[6] **Questions for Mr Forrest:**

**[7] Questions for Ms Baugham:**

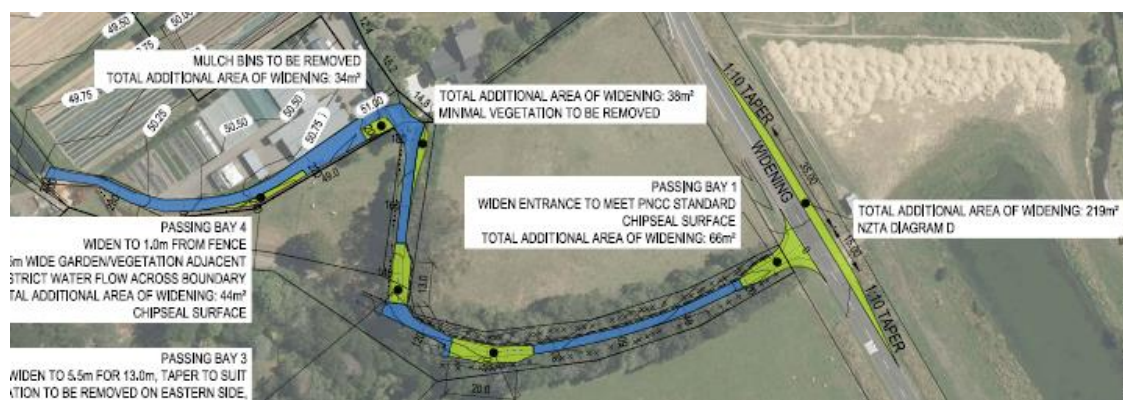
However, in the Section 92 Response #3, the increased paved areas was updated but the supporting calculations were not provided. It also did not include the change in surface type noted above. It appears that the additional impervious area more than tripled, however a significant portion is along Turitea Road itself. Below compares the impervious area supported by the calculations, and the impervious area without calculations.

Increased Impervious Areas (m <sup>2</sup> )		
	s92 #2	s92 #3
Turitea Rd	0	219
Passing Bay 1 / Entranceway	66	66
Passing Bay 2	14	41
Passing Bay 3	28	37
Passing Bay 4	44	44
Corner widening	0	72
Sealed ROW	?	?
<b>TOTAL</b>	<b>152</b>	<b>479</b>

Additional information is required, however in my opinion I believe the increase in runoff can be appropriately managed.
